Planning and Zoning Board Agenda August 11, 2020

- C. Site Plan – Burger King (16130 NW US Highway 441): A request by Robin Kendall of Quality Dining, Inc., applicant and agent, for T&H Property Group, LLC, property owner, for consideration of a Site Plan to construct a ±3,349 square foot quick service restaurant with associated parking, stormwater, landscaping, and site improvements on a ±1.19 acre subject property. Tax Parcel Number 03061-004-001 (Quasi-Judicial Hearing).

PREPARED BY: Justin Tabor, AICP, Principal Planner

CROSS SECTIONS
BURGER KING
16130 NW U.S. HIGHWAY 441
CITY OF ALACHUA, FLORIDA
SCALE: 1"=20' DATE: 1.15.20
CAD FILE: C05B-SECTIONS
JOB NUMBER: ALACHUA COUNTY
SHEET C05B

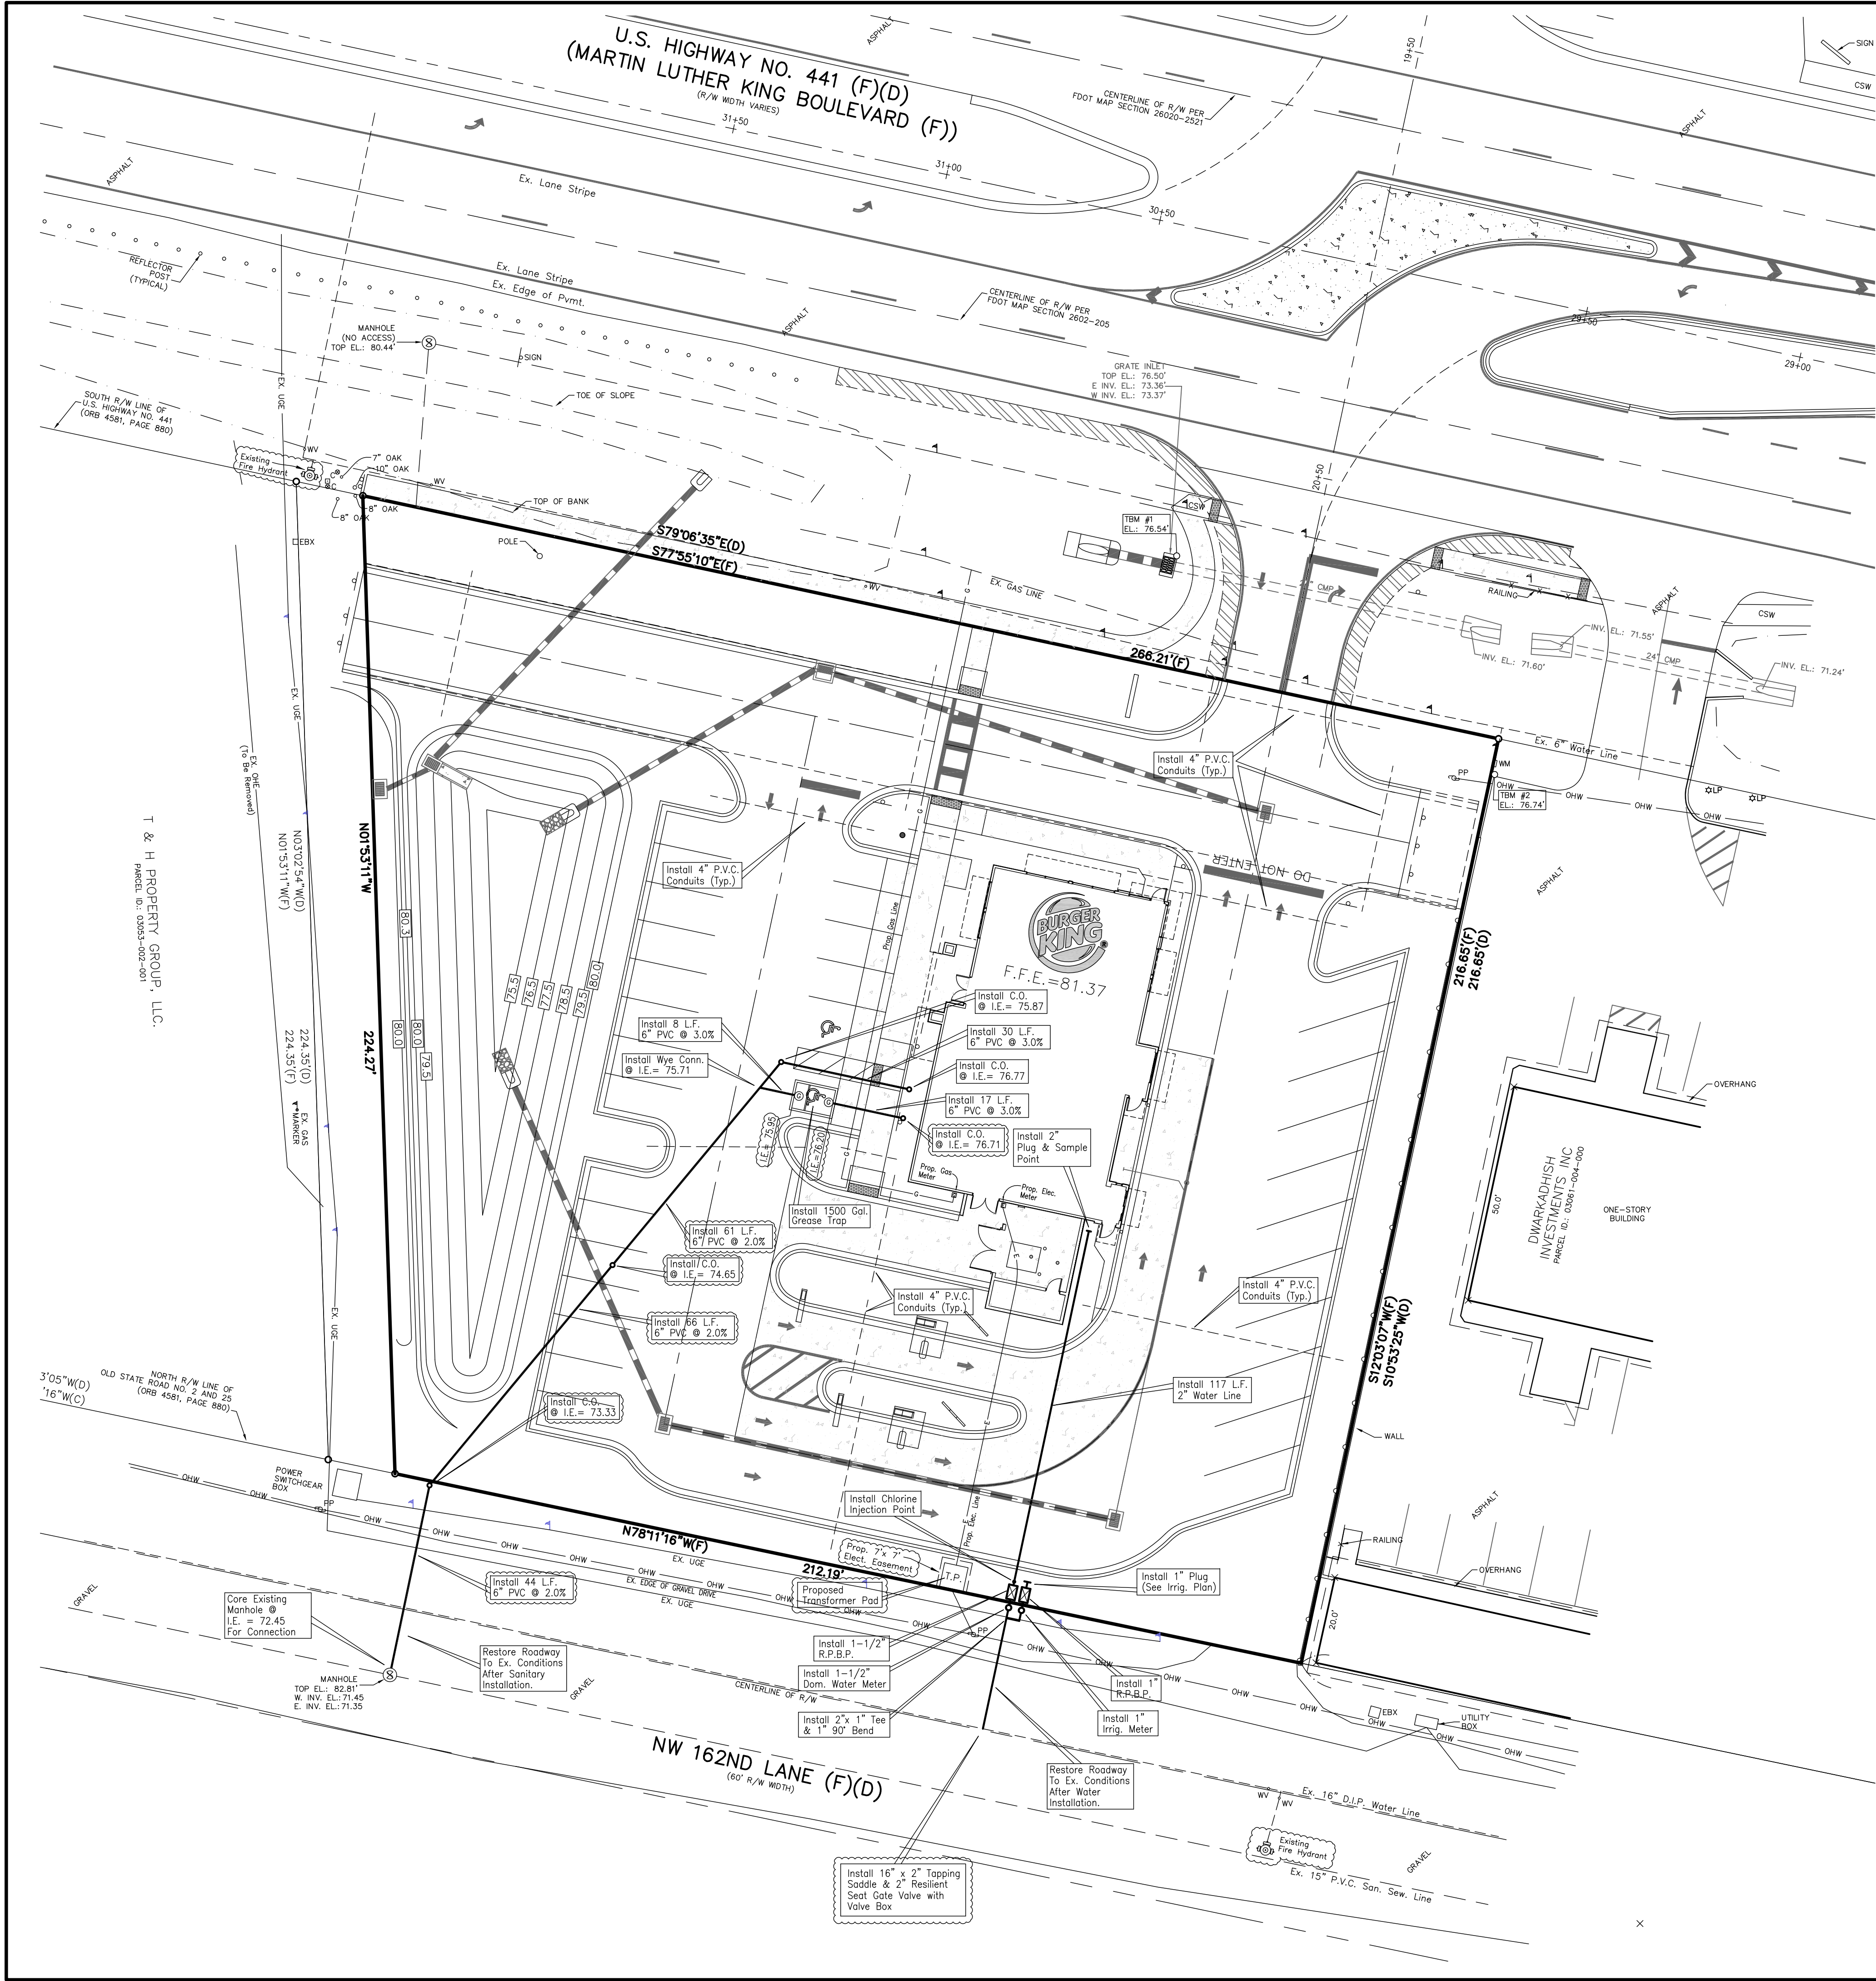
NO.	COMMENTS
	reduces staff-traffic interface.
3.	Comment on Jan 12th Submittal Sheet C05A: To enhance clarity, suggest changing the pavement legend text to: • “Standard Duty Asphalt (See U.S. 441 Driveway Pavement Detail)” • “U.S. 441 Shoulder Asphalt (See Shoulder Pavement Detail)”

Response: Sheet C03 specifies the existing pavement onsite and within U.S. 441. To be removed and sheet C04 and sheet C05A shows the proposed pavement both onsite and within U.S. 441.
